TRANSMITTAL OF CHANGE REQUEST (CR) M-24-00-02, ESTABLISH
CALENDAR YEAR 2001 RCRA WELL INSTALLATION INTERIM MILESTONES IN
SUPPORT OF HANFORD FEDERAL FACILITY AGREEMENT AND CONSENT ORDER
(TRI-PARTY AGREEMENT) MAJOR MILESTONE M-24-00M

Change Number M-24-00-02	Federal Facility Agreement and Consent Order Change Control Form <small>Do not use blue ink. Type or print using black ink.</small>	May 22, 2001
Originator Jane Hedges, Ecology		Phone 509-736-3016
Class of Change <input type="checkbox"/> I - Signatories <input checked="" type="checkbox"/> II - Executive Manager <input type="checkbox"/> III - Project Manager		
Change Title Establish calendar year 2001 RCRA well installation interim milestones in support of Hanford Federal Facility Agreement and Consent Order (HFFACO) Major Milestone M-24-00M.		
Description/Justification of Change <p style="text-align: center;"><u>Introduction:</u></p> Regulatory requirements applicable to the generation, transport, storage, treatment, and/or disposal of hazardous and mixed wastes are established by the <i>Resource Conservation and Recovery Act of 1976 (RCRA)</i> , Washington's Hazardous Waste Management Act (HWMA), and the HFFACO, as amended. The

WMA TX-TY Proposed Well Locations and Surrounding Facilities

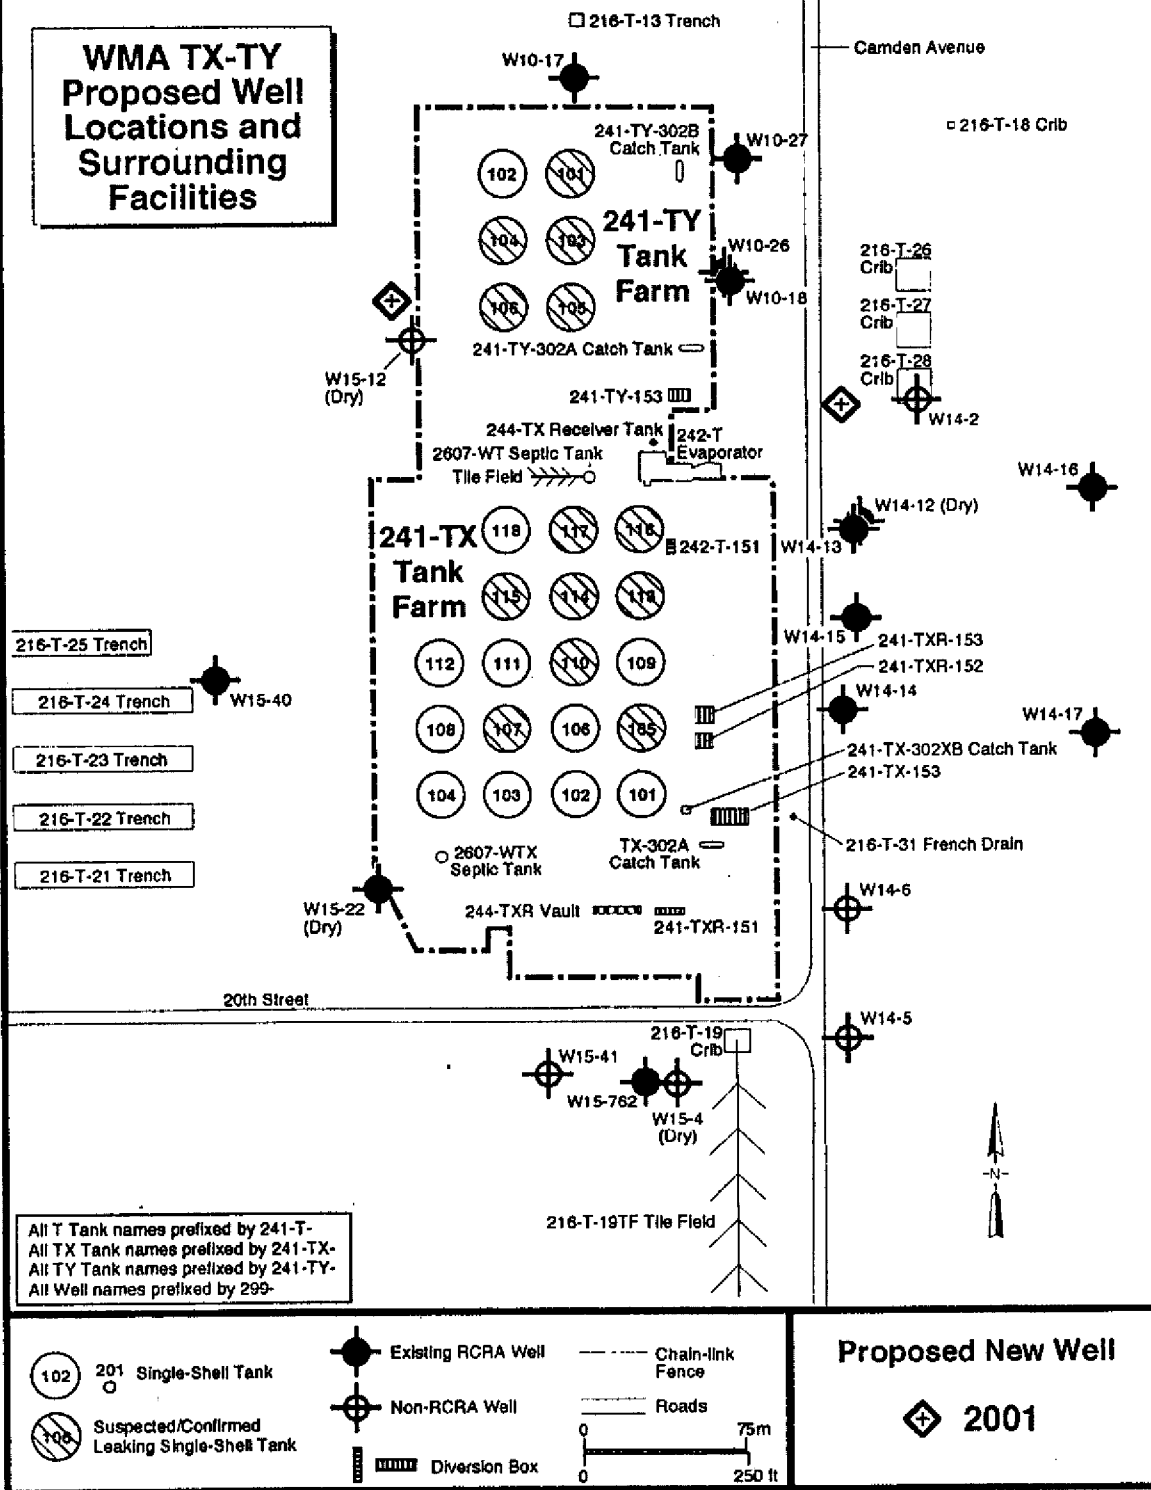
TX-TY	A	Y	1	Site in assessment. Contaminant detection/enhance downgradient coverage		Downgradient (perimeter), near non-RCRA well 299-W14-2.
TX-TY	B	Y	5	Site in assessment. Evaluate contaminant depth distribution, monitor at depth.	X	Downgradient assessment well, monitor at depth near well 299-W14-2.
TX-TY	C	Y	3	Site in assessment. Contaminant detection/enhance downgradient coverage		Downgradient (perimeter), located between wells 299-W14-6 and 299-W14-14.
TX-TY	D	Y	6	Site in assessment. Evaluate contaminant depth distribution, monitor at depth.	X	Downgradient assessment well, monitor at depth near well 299-W14-13.
TX-TY	E	Y	4	Site in assessment. Contaminant detection/enhance downgradient coverage		Downgradient (perimeter), located west of 299-W15-41.

Facility Name	Well ID	Keep on List?	Well Priority	Justification/Purpose	Deep Well	Location
TX-TY	F	Y	7	Site in assessment. Evaluate contaminant depth distribution, monitor at depth.	X	Downgradient assessment well, located adjacent to 299-W15-41.
TX-TY	G	Y	2	Site in assessment. Upgradient well		Upgradient, north end of the west side of the facility. Replaces drying well 299-W15-12.
TX-TY	H	Y (Added)	0**	Proposed for current drilling campaign (priority i).	X	Downgradient assessment well, located adjacent to newly installed well 299-W14-15.
S-SX	A	Y	1	Site in assessment. Contaminant detection/enhance downgradient coverage		Downgradient (perimeter), toward southern end of east side (well #14 on MEMO simulation).
S-SX	B	Y	2	Site in assessment. Contaminant detection/enhance downgradient coverage		Downgradient (perimeter), on northern end of east side (well #13 on MEMO simulation).
S-SX	C	See →	Defer*	Site in assessment. Contaminant detection/enhance downgradient coverage		Downgradient (perimeter), if needed. Evaluate current year's findings before deciding need/location.
